Project Description – 1201 Abercorn Street

This application covers two minor changes to the project originally proposed and approved by the Historic Preservation Commission in COA 24-002994. Besides the changes listed below, the exterior scope remains the same as originally approved. This application only contains information about the changes.

1201 ABERCORN IMPROVEMENTS

A5.3

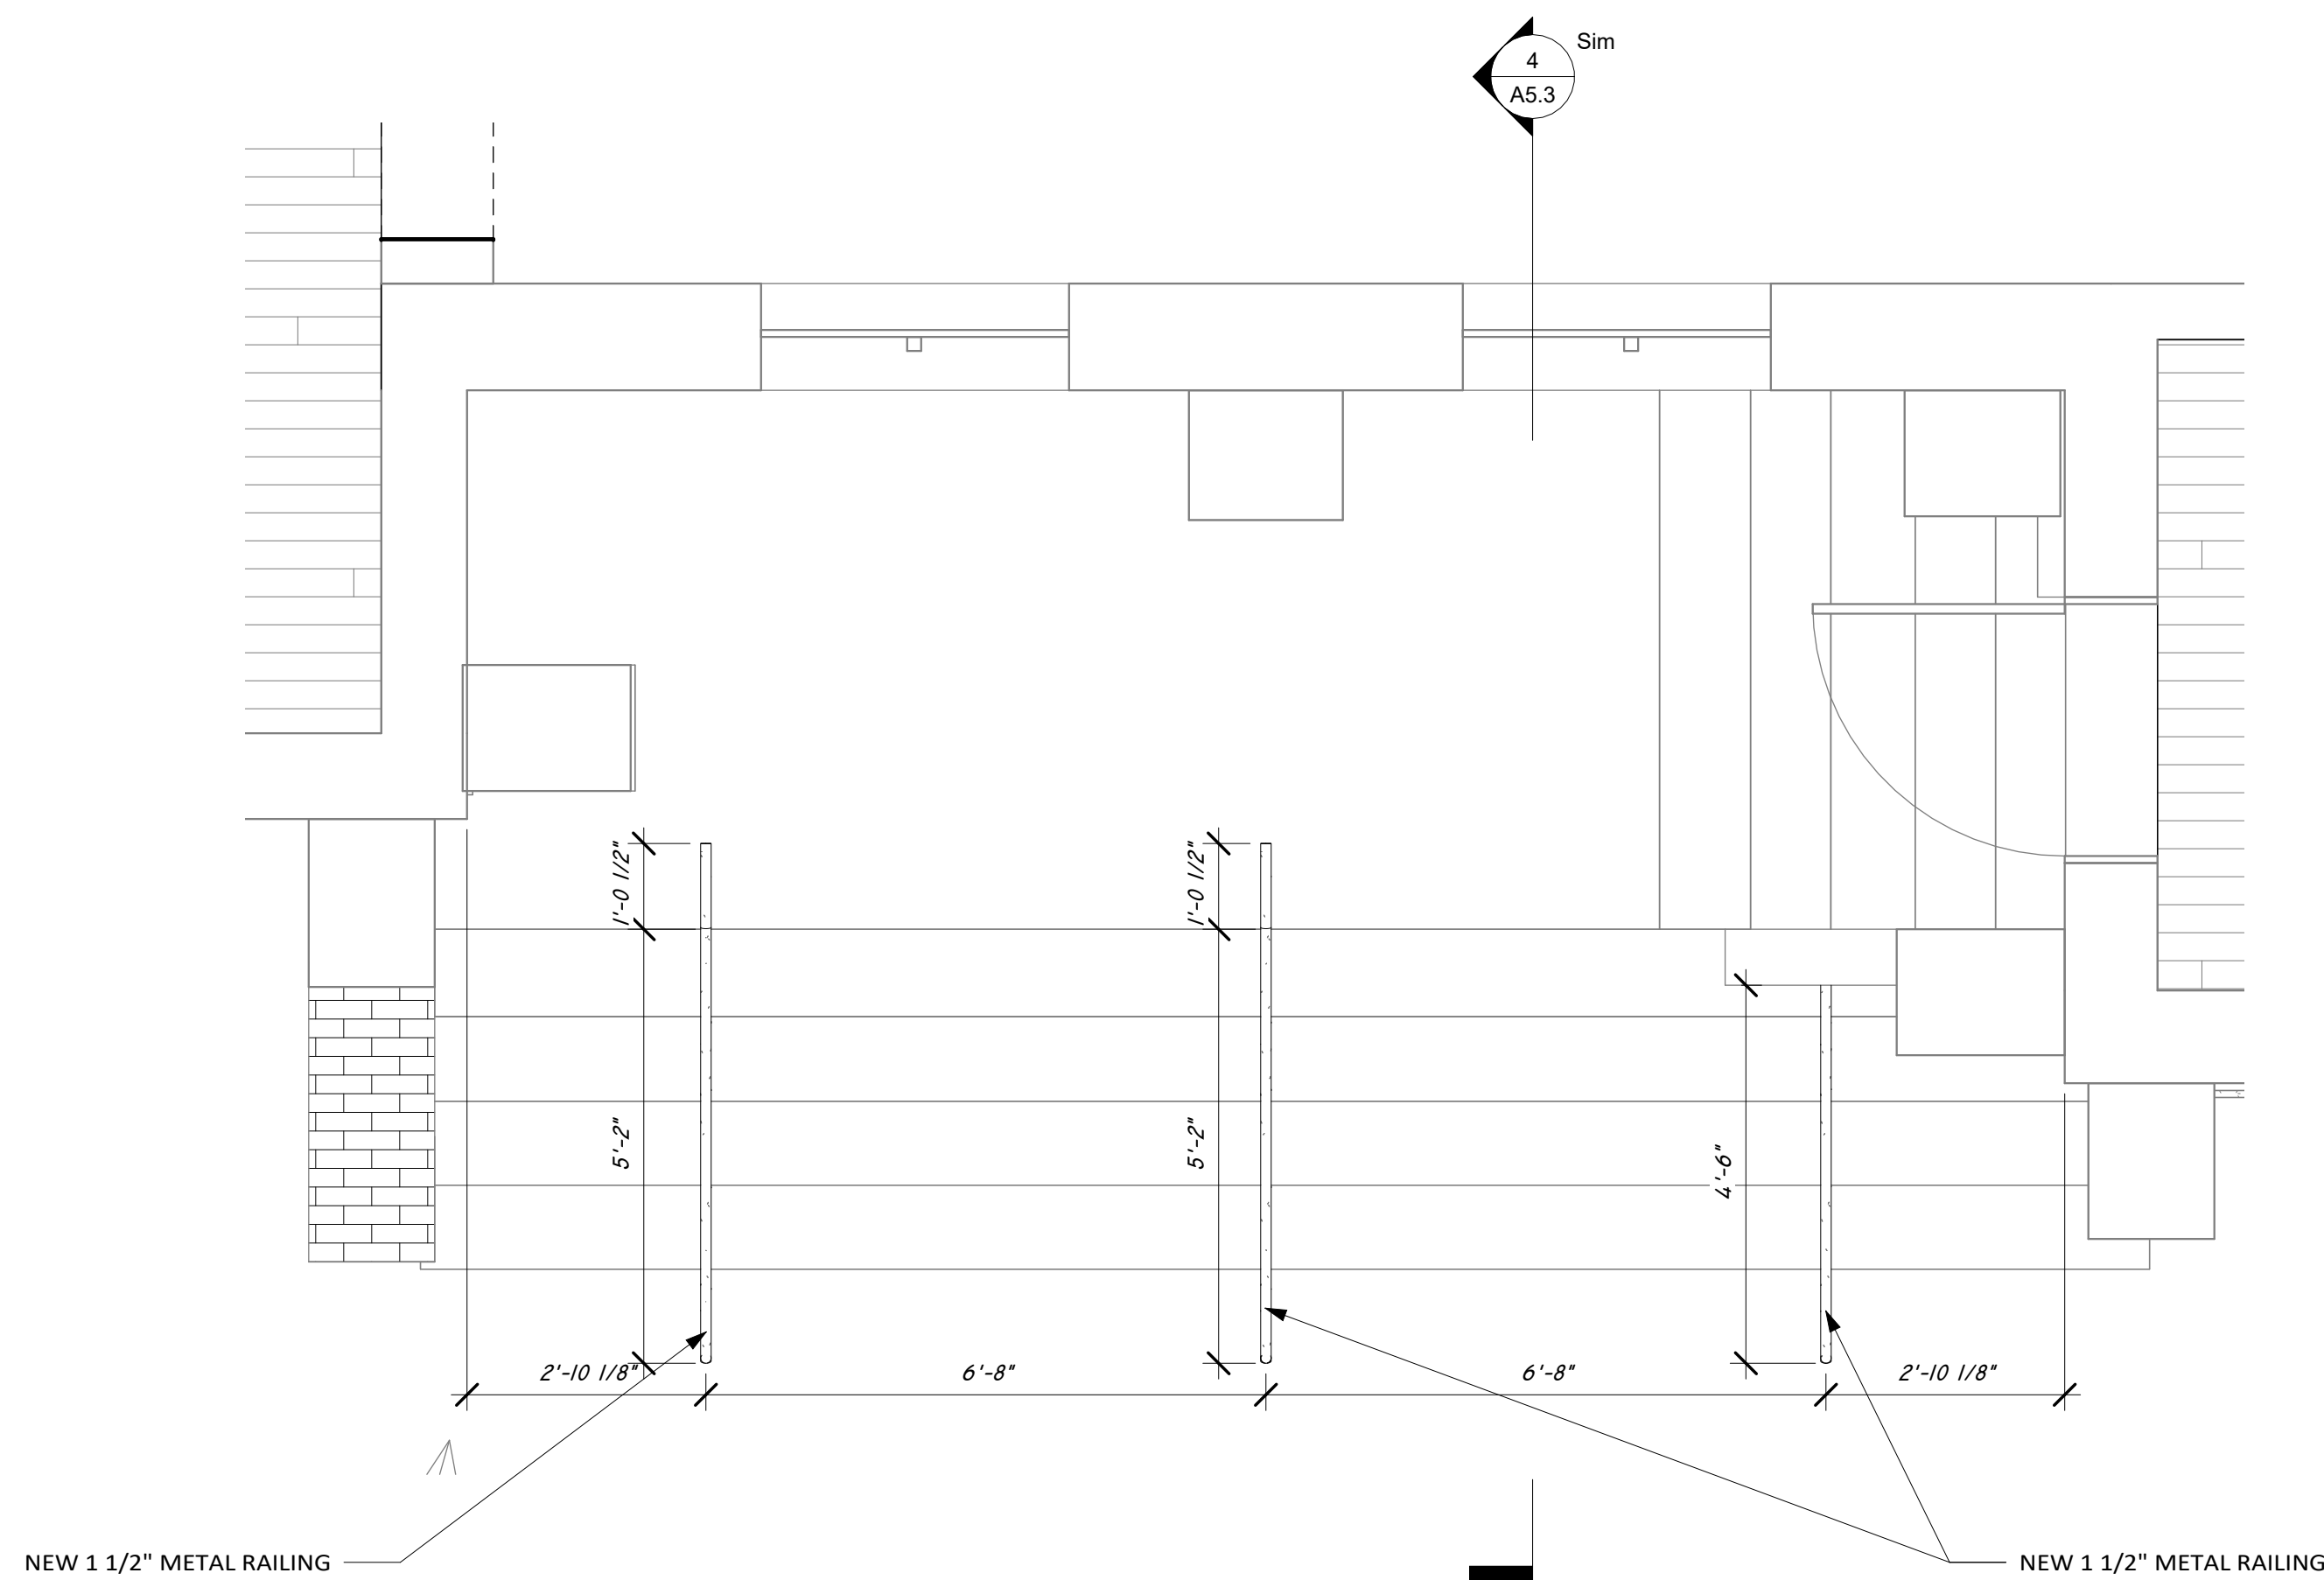
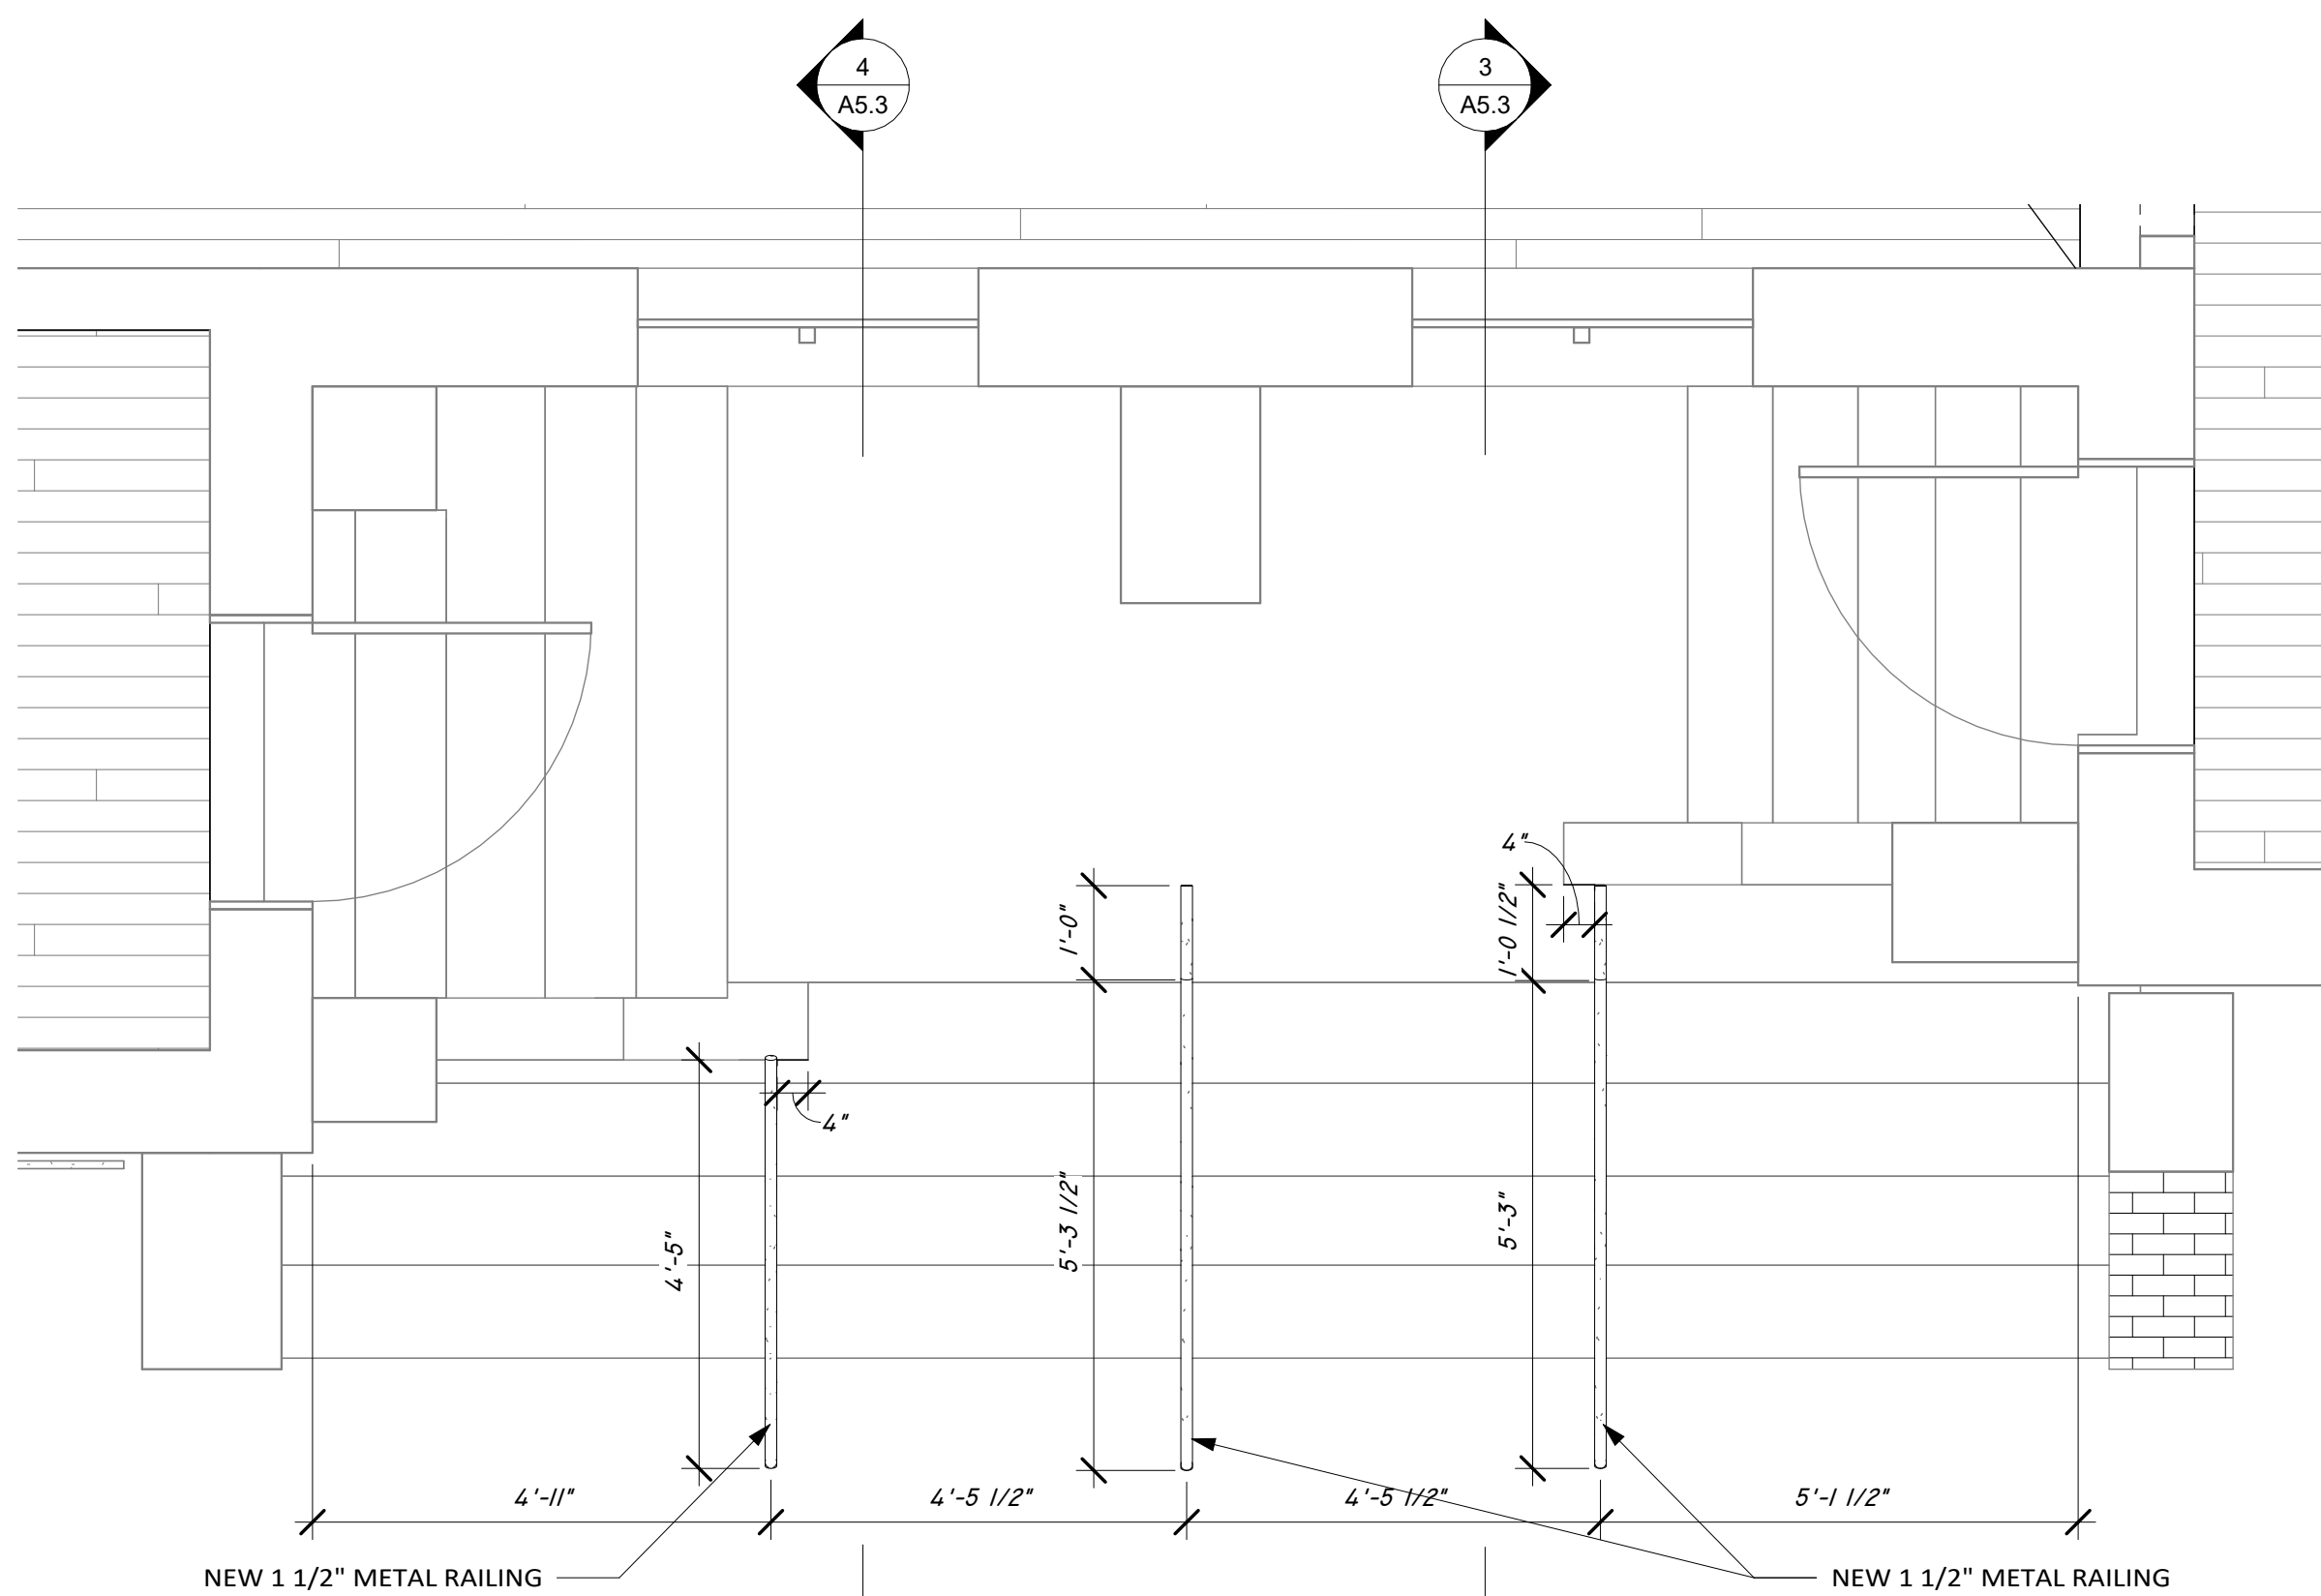
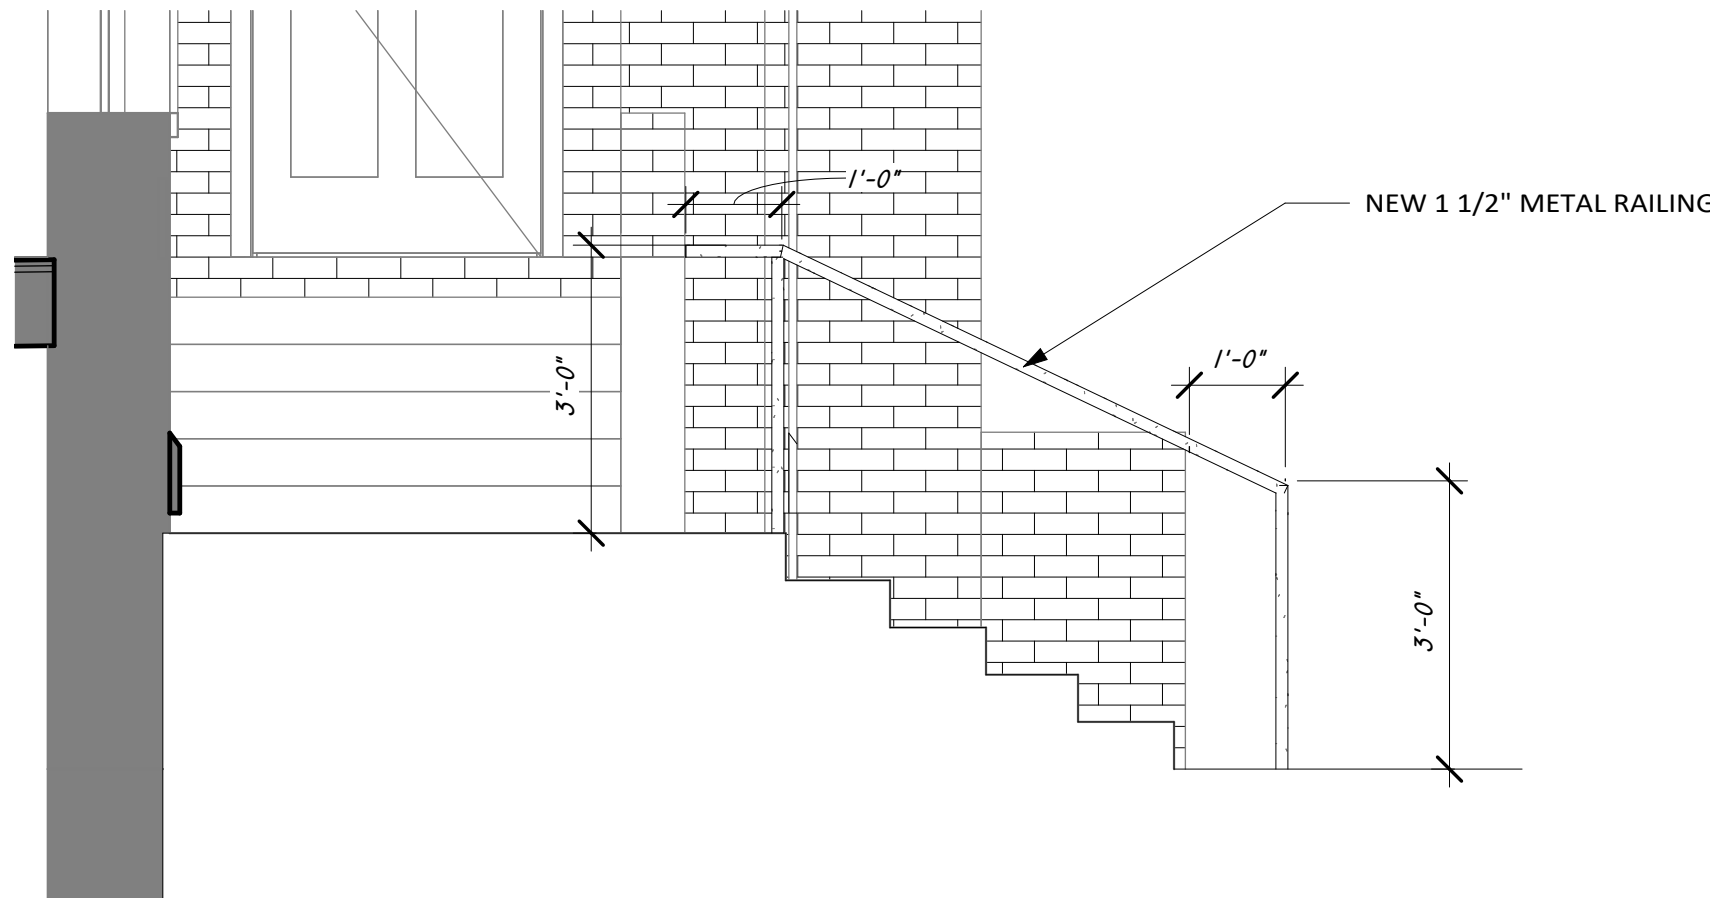
The handrails on the main steps on the east elevation (front) were removed per the previous proposal. In order to meet life/safety codes, new handrails will be installed. The new handrails will be simple metal handrails that are finished with a dark powder coated finish. These handrails will be minimally visible once installed. See sheets A1.1 and A5.3 for locations and details of these handrails.
